The enclosed Traffic Impact Study (TIS) review letter for the **Georgetown Crossing** commercial development has been completed under the responsible charge of a registered professional engineer whose firm is authorized to work in the State of Delaware. They have found the TIS to conform to DelDOT's Standards and Regulations for Subdivision Streets and State Highway Access and other accepted practices and procedures for such studies. DelDOT accepts this review letter and concurs with the recommendations. If you have any questions concerning this letter or the enclosed review letter, please contact me at (302) 760-2167.

RE: Agreement No. 1529
Traffic Impact Study Services
Task No. 14A – Georgetown Crossing

McCormick Taylor has completed its review of the Traffic Impact Study (TIS) for the Georgetown Crossing Shopping Center development prepared by Traffic Planning and Design, Inc. (TPD), dated September 2012. This review was assigned as Task Number 14A. TPD prepared the report in a manner generally consistent with DelDOT's *Standards and Regulations for Subdivision Streets and State Highway Access*.

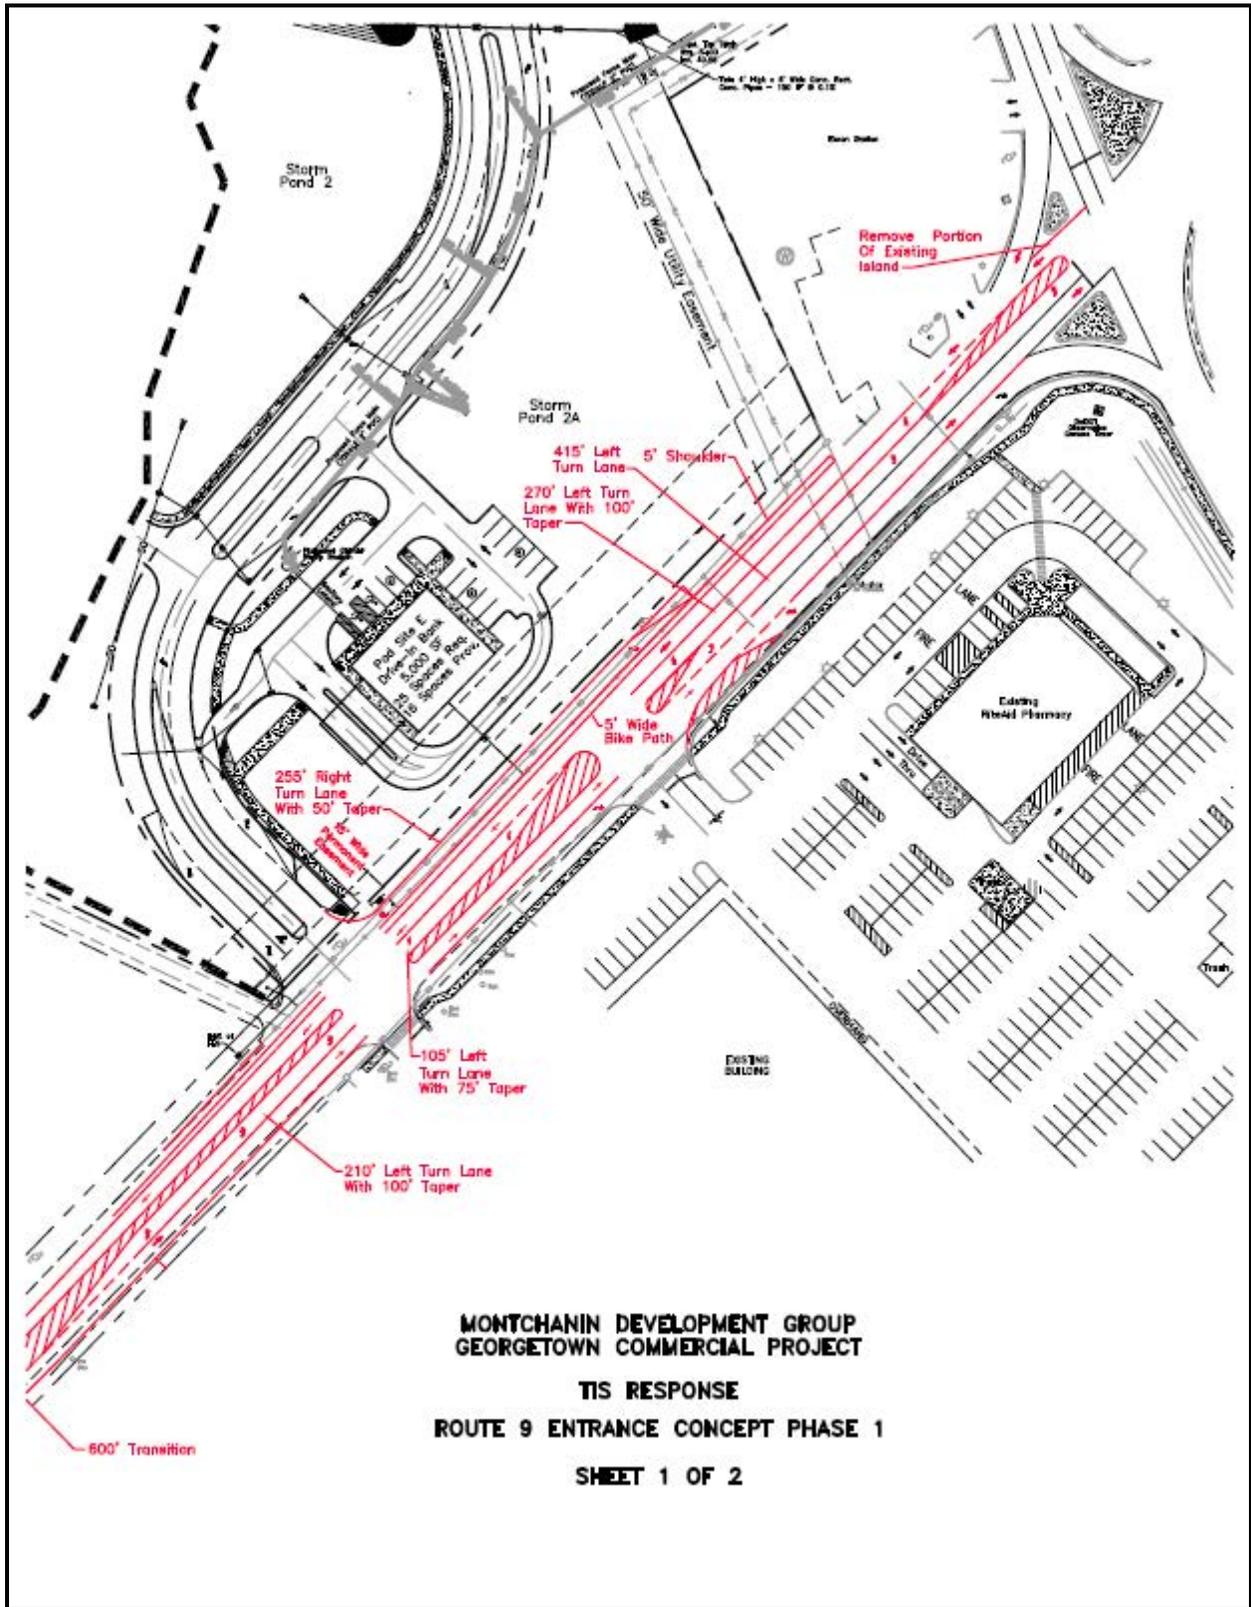
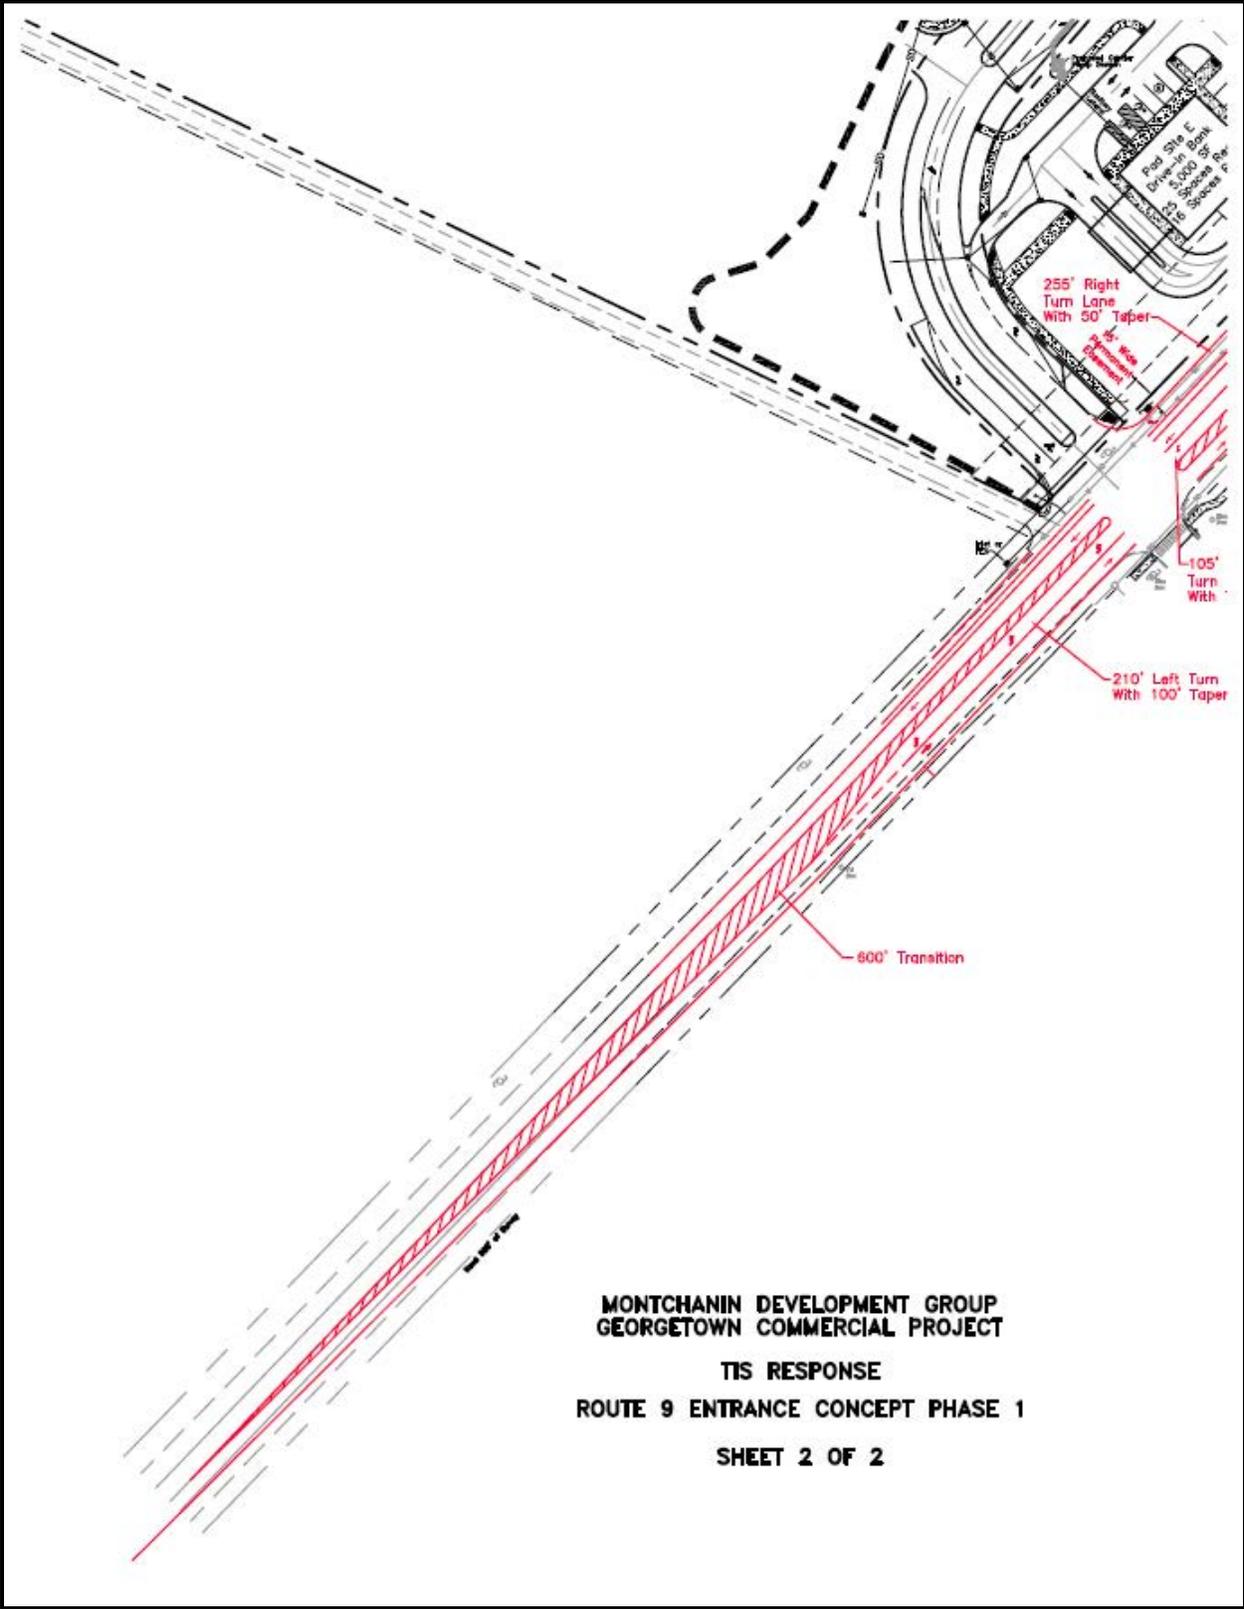
Regarding the shopping center entrances on US Route 9, the developer and DelDOT have worked together to establish proposed intersection configurations and improvements along US Route 9. These configurations and improvements are consistent with the recommendations described below in Item Nos. 2 and 3. They are depicted in the concept plan for widening and associated improvements along US Route 9 from US Route 113 to west of the shopping center truck entrance / proposed Georgetown Crossing site entrance, which is provided below in Item No. 4. DelDOT has reviewed this concept plan and finds it to be acceptable.

4. The developer should improve US Route 9 from US Route 113 to west of the Food City Shopping Center Truck Entrance / Proposed Georgetown Crossing Site Entrance by widening the road as needed and providing turn lanes consistent with the proposed intersection configurations described above in Item Nos. 2 and 3. A concept plan of the US Route 9 improvements and entrance design is provided on Pages 7 and 8.

**TIS RESPONSE
BUS STOP CONCEPT
SHEET 1 OF 1**

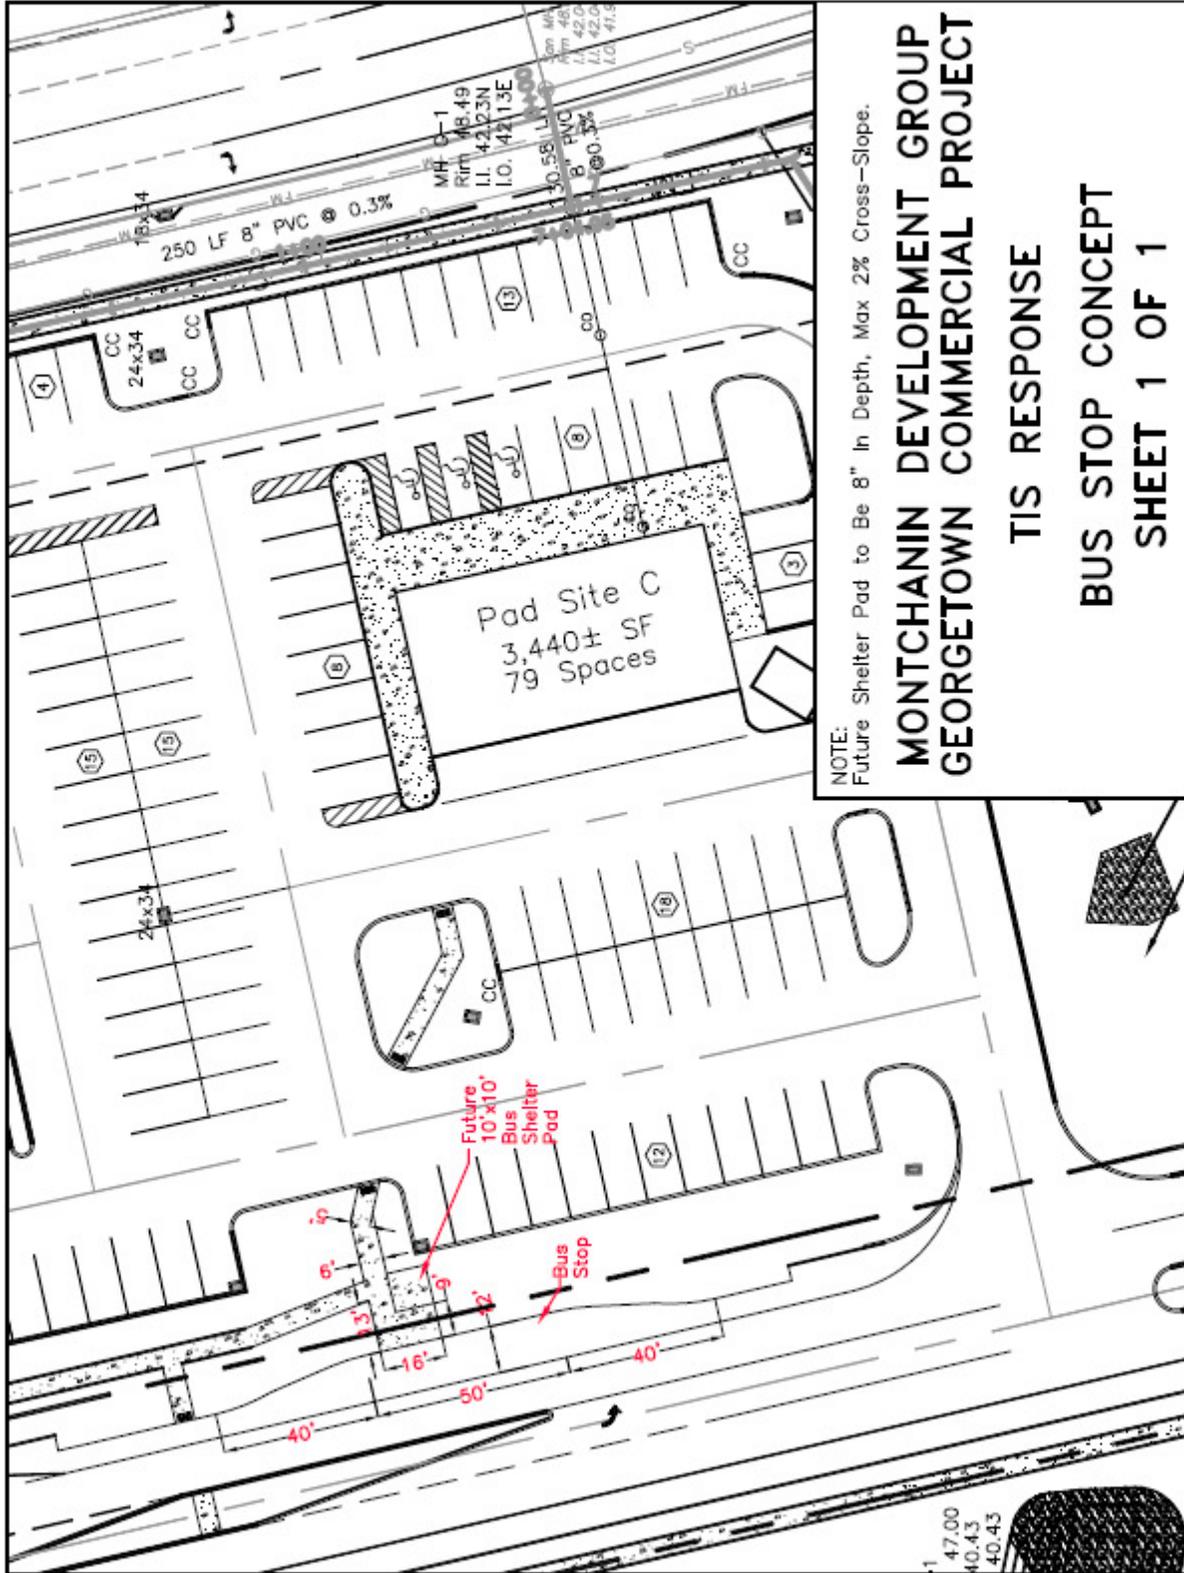
- l. Where internal sidewalks are located alongside of parking spaces, a buffer should be added to eliminate vehicular overhang onto the sidewalk.
 - m. The developer should coordinate with the Delaware Transit Corporation (DTC) regarding the possibility of adding a bus pull-off within the site along the northbound side of the major internal road, near the proposed pad sites (restaurants along US Route 113). Having already begun coordination with DelDOT and DTC on the design of this bus pull-off, the developer has provided a concept plan that is included on Page 11. Internal sidewalks should be connected to this proposed bus pull-off, and parking facilities for bicyclists should be included. The developer should continue to coordinate with the DTC regarding the details and implementation of the transit-related improvements.

NOTE:
Future Shelter Pad to Be 8" In Depth, Max 2% Cross-Slope.
